TO: Portland City Council  
FROM: Hillsdale Neighborhood Association  
RE: Ida B. Wells Modernization LU 26-026160 CU AD  
Appeal of Hearings Officer Decision  
DATE: September 10, 2026

## INTRODUCTION

Site Plan

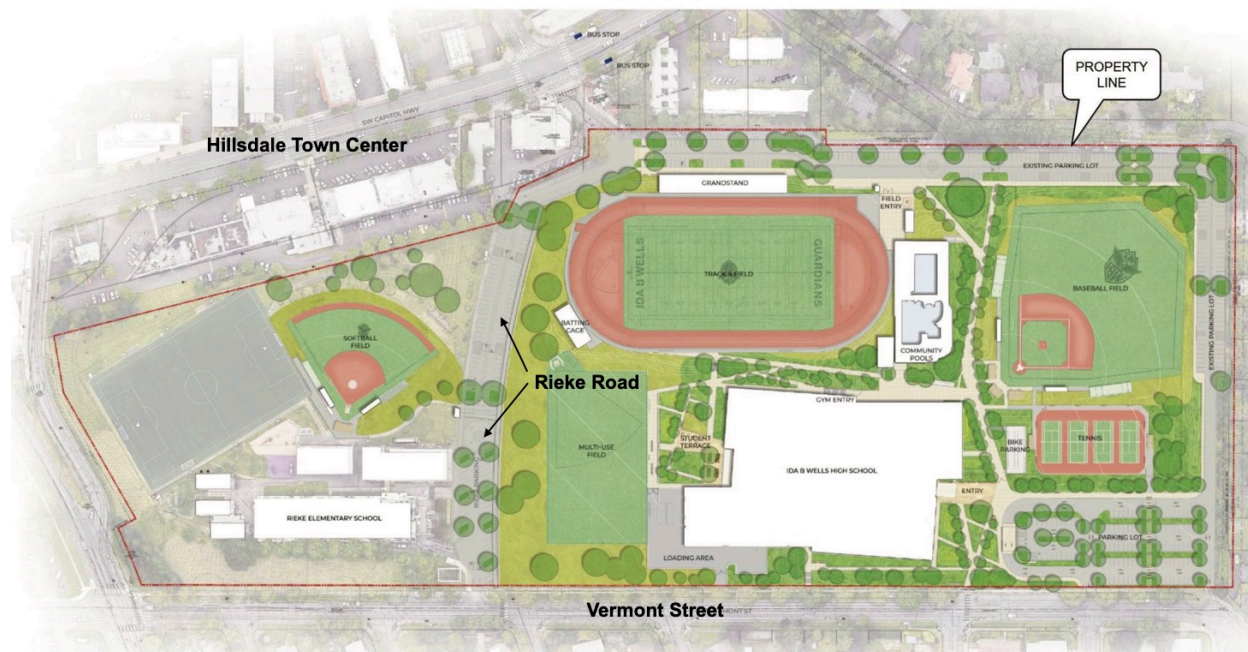
For decades, Rieke Road has not only provided access for Rieke Elementary and Wells HS students, it has also served as a critical pedestrian and bicycle access between Vermont Street and Hillsdale Town Center. With a Vermont Street frontage of well over 2,000 feet, the 35-acre Wells/Rieke property represents a significant neighborhood circulation barrier with Rieke Road providing an invaluable north-south connection (site plan below), which has been recognized in adopted city plans for years. The existing facility includes pathways on both sides of the

driveway for pedestrians and the driveway that allows for bicycle, e-bike, and e-scooter access. It functions like the neighborhood greenways found throughout the city by providing safe on-site circulation for students, district staff, visitors, and local residents.

**Because PPS is unwilling to voluntarily grant an access easement that would allow continued cyclist use of the driveway, we must assume PPS intends to ultimately close this access as shown in its first application submittal (Ex. A-2, Plan Sheet LU L1.03, A-G Exhibits package), forcing all walkers and cyclists to share the existing 6' to 7'-wide east side pedestrian path as a multi-use path, which is subject to periodic encroachment and does not remotely satisfy city standards for this type of facility. It would be equivalent to closing a neighborhood greenway street to cyclists and forcing them to ride the sidewalk on one side of the street.**

To ensure adequate long-term pedestrian and bicycle access through the site between Vermont Street and Hillsdale via Rieke Road and to provide safer on-site access for students, staff, and visitors, amend Condition D. of the Hearings Officer decision as follows:

*The applicant shall submit the four public access easement agreements consistent with those shown and described in Exhibit A-30 to the City of Portland with the school building permit application for review and approval by the City Attorney. The public access easements must be executed and recorded prior to issuance of the building permit for the school building. The easement agreements will identify the post-construction effective date of public access as well as other essential terms, such as hours of operation and emergency closure restrictions, consistent with Exhibit A-30. The public access easements granted through this project must allow bicycle access for mounted cyclists for routes outside of the fence line, including a modification of Easement 1 to include the Rieke driveway for bicyclists and the east pathway for pedestrians. In addition, the sharrows treatment proposed for the north and east driveways shall also be provided for the Rieke driveway.*

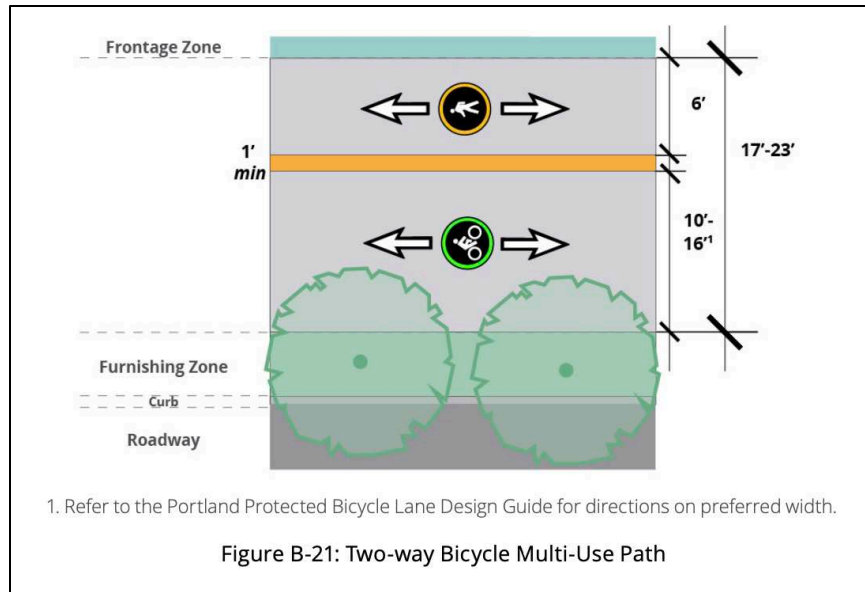
The staff and Hearings Officer failed to acknowledge and address the relevant approval criteria in 33.815.100 and 33.815.105 as they pertain to Rieke Road as explained beginning on page 5.

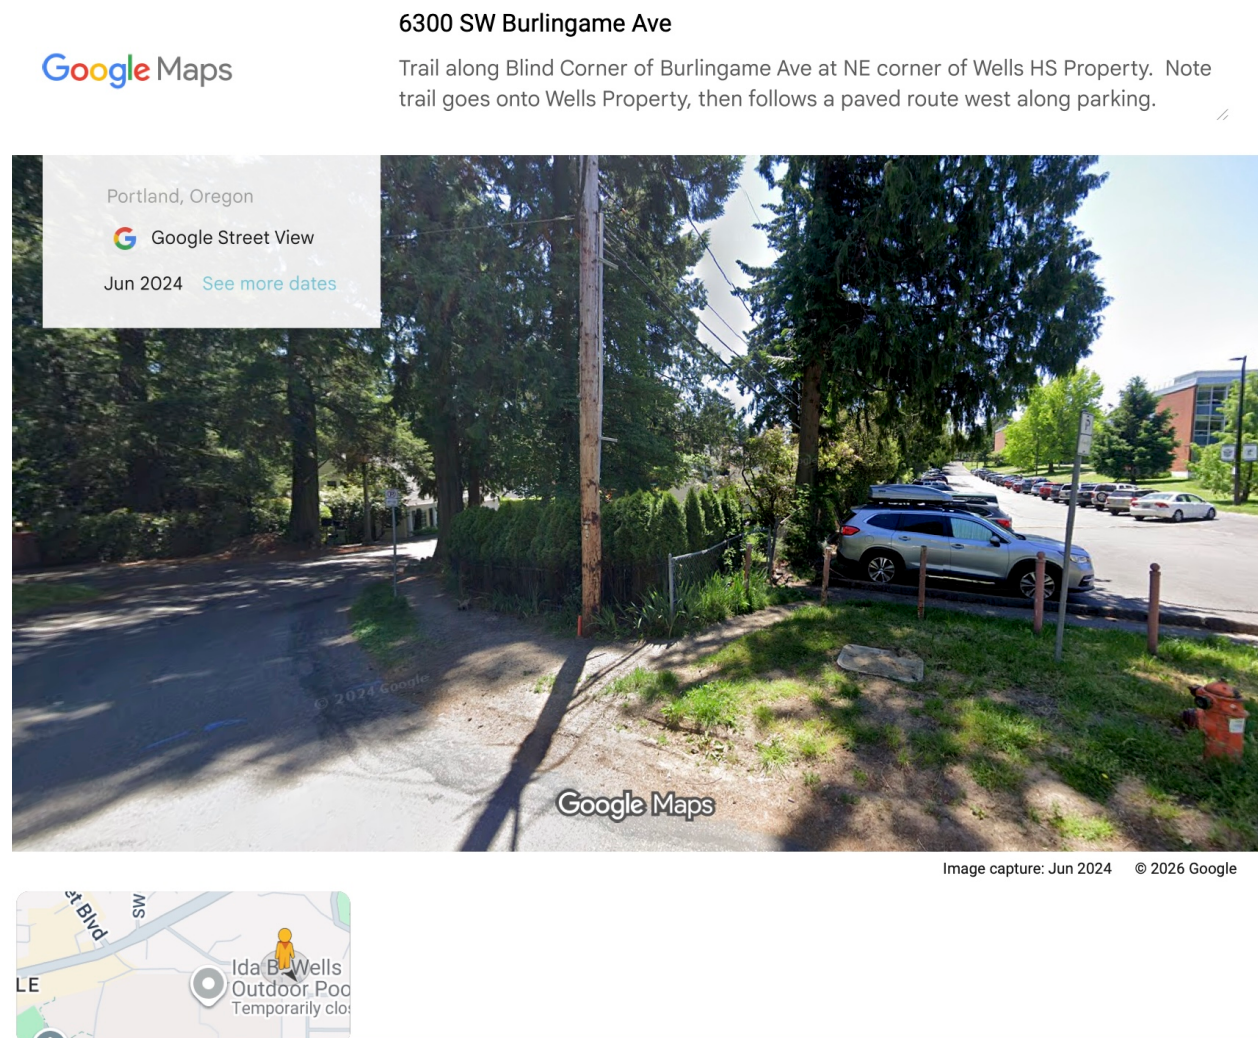
An off-road pedestrian route from the east onto PPS property currently exists and is very heavily used. It provides a Safe Route to School route to Rieke and Robert Gray schools, as well as being the shortest and safest connection to the Hillsdale commercial area, Wells Pool, the soccer field, and the Hillsdale Farmers Market.

The current PPS plan would remove this safe route and instead require pedestrians—including children—to walk in the street along PPS property. Safety for pedestrians could be maintained by building a short segment of sidewalk on the public right of way along the PPS frontage, or by modifying the existing conditions at a lower cost.

PPS plans landscaping in the northeast corner of the property, which would require removing the existing asphalt paving. Instead of removing the asphalt paving, a practical, lower-cost solution is to remove the curb and widen the path on existing asphalt to 6 feet and we have a safe, off-street pedestrian route connection to the existing path everyone uses. This approach could save PPS construction costs by not having to remove and process the existing asphalt and by reducing the area of landscape to be maintained in the future.

*Prior to issuance of final occupancy for the Ida B. Wells High School replacement project, Portland Public Schools shall provide and maintain a safe, accessible, off-street pedestrian connection at the east campus entrance along the SW Burlingame Avenue frontage. The connection shall preserve the existing pedestrian route between SW Burlingame Avenue and the existing campus path system and shall not require pedestrians to walk in the street along PPS property*

### 6310 SW Burlingame Ave

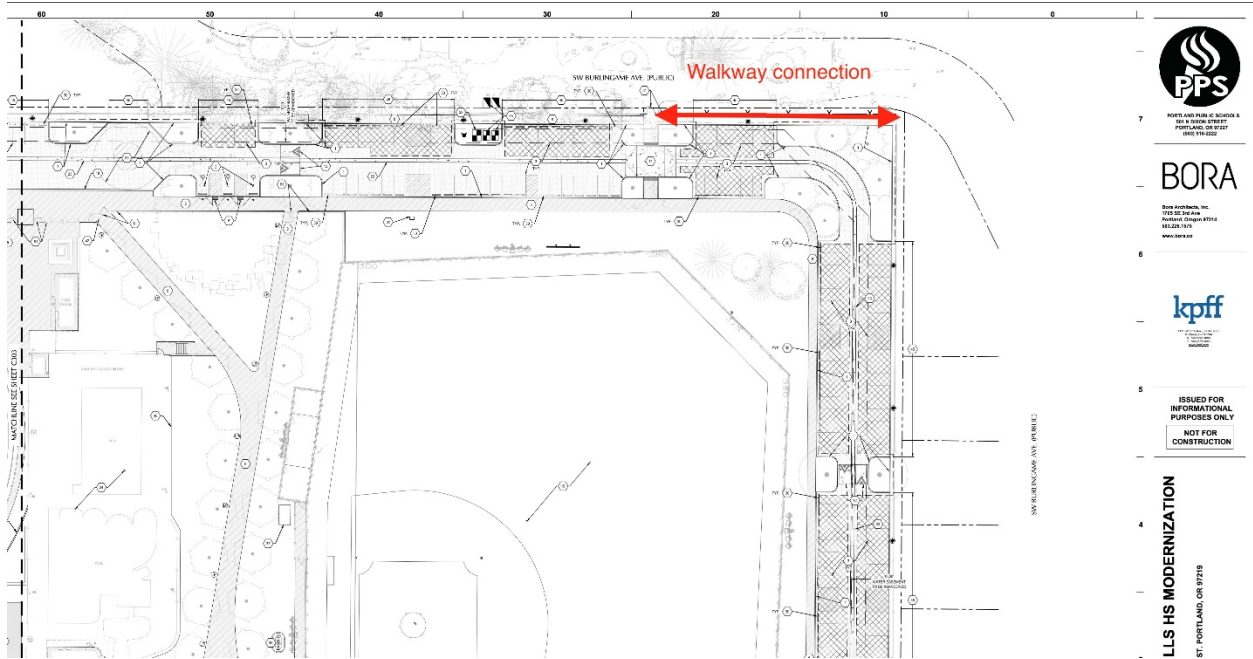
NE Corner of PPS is at left beyond pole. This is where PPS asks children to walk in the street. They need a short sidewalk to new entrance.

The red line shows the needed sidewalk.

The tape measure in foreground shows the width of the needed asphalt path.

### Existing Conditions

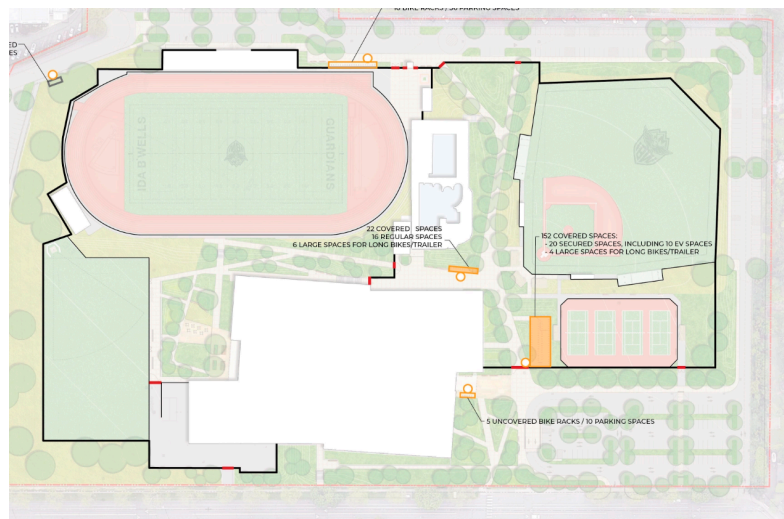
This screenshot shows the extent of the outdoor spaces currently accessible to the public: Baseball field, practice field, tennis courts, east courtyard, garden, west side of school.

### After Construction

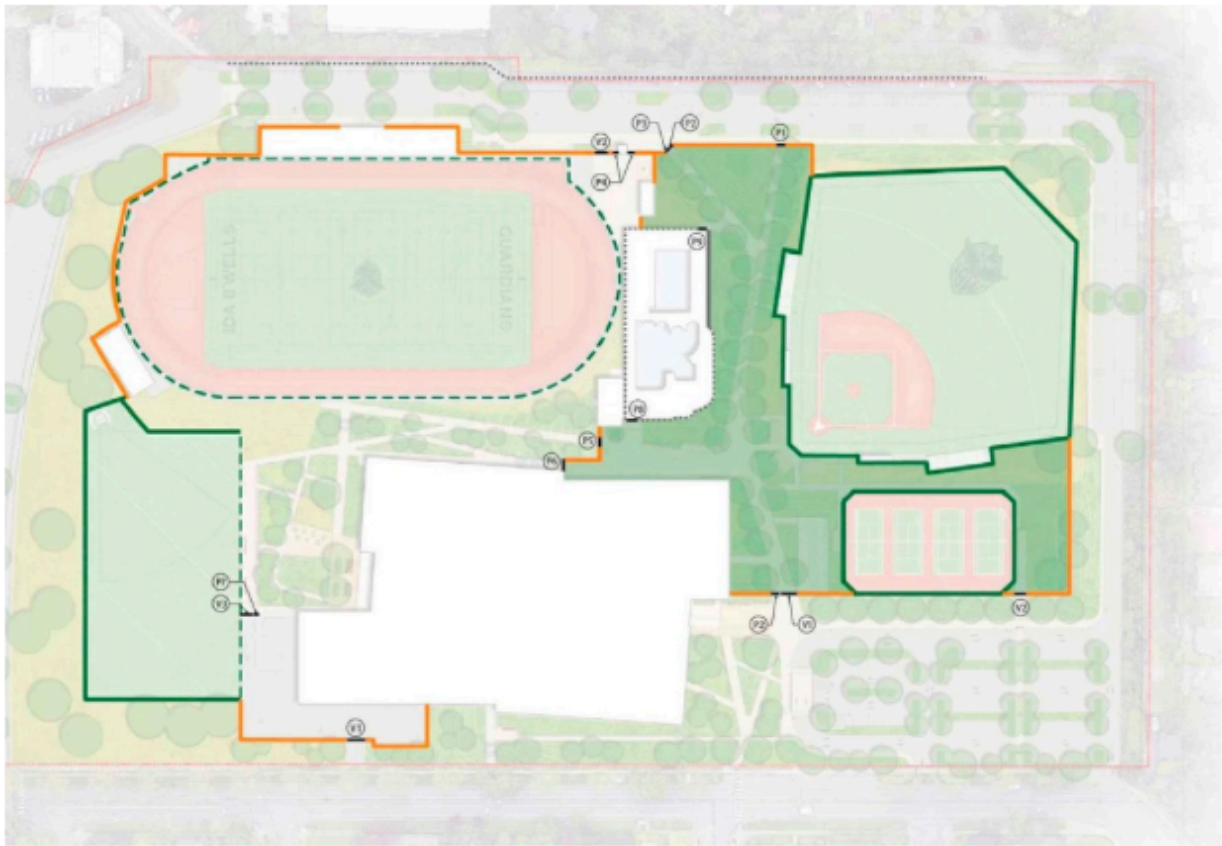
Everything inside the black line will be fenced with access controlled by time lock gates. The Gates and Fences

Legend indicates that the gate to the track will be open outside of school hours, however, we have no assurances that in the future the track will remain accessible. The

Legend also indicates that the gate to the through-campus pathway will be open after school hours. All other outdoor spaces (ball fields, practice field, courtyard, tennis courts) will be off-limits to the public.

*To ensure consistency with the Hillsdale Town Center Plan and the Southwest Community Plan, the applicant shall provide continued public access to outdoor campus open-space areas and recreational facilities, including the athletic fields, track, practice field, courtyard, and tennis courts, during non-school hours when those areas are not reserved for school activities, athletics, maintenance, or other authorized uses. Such access shall include casual, non-organized community use and organized activities through the existing reservation process.*
